Access Compliance Report

Public Rights-of-Way

Intersection ID: 31730	Main Street: RAISIN_TREE_LN	Cross Street: LEAF_PLUM_DR	Location: SW
ADA ID: 370796315DAB	Ramp Type: PerpDiag	Initial Pass/Fail: Fail	Overall Compliance: No
		Severity Score: 22.5

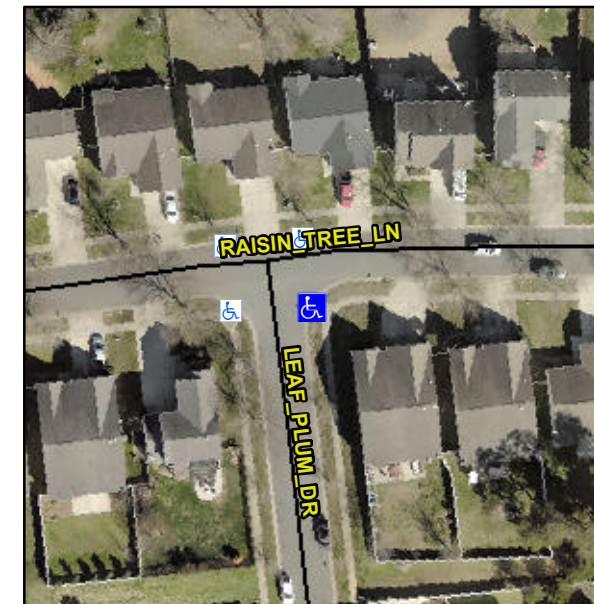
Not Found, R304.5.1, R304.2.2, R304.5.3

Compliance	Description	Data	Compliance	Description	Data
N/A	Ramp Length (in)	90.5	No	Ramp Slope (%)	10.1
No	Ramp Width (in)	47.0	No	Ramp XSlope (%)	3.3
N/A	Flare Type LT	N/A	N/A	Flare Type RT	N/A
N/A	Flare Slope LT (%)	N/A	N/A	Flare Slope RT (%)	N/A
N/A	Flare Traversable LT?	N/A	N/A	Flare Traversable RT?	N/A
N/A	Landing Length (in)	N/A	N/A	DWS Provided?	N/A
N/A	Landing Width (in)	N/A	N/A	DWS Contrast?	N/A
N/A	Landing Slope (%)	N/A	N/A	DWS Length (in)	N/A
N/A	Landing X Slope (%)	N/A	N/A	DWS Full Width?	N/A
N/A	Landing Curb? (Y/N)	N/A	N/A	DWS Offset (in)	N/A
N/A	Shared Landing?	N/A			
N/A	Gutter Ponding?	N/A	N/A	Gutter Slope (%)	N/A
N/A	Gutter Lip Ht (in)	N/A	N/A	Gutter X Slope (%)	N/A
N/A	Painted X Walk1?	No	N/A	Painted X Walk2?	No
	X Walk 1 Direction	To N		X Walk 2 Direction	To W
N/A	X Walk 1 Width (in)	N/A	N/A	X Walk 2 Width (in)	N/A
	X Walk 1 Slope (%)	4.4		X Walk 2 Slope (%)	2.0
	X Walk 1 X Slope (%)	0.8		X Walk 2 X Slope (%)	1.7

Remove & Replace Curb Ramp With Two New Directional Ramps or Equivalent.
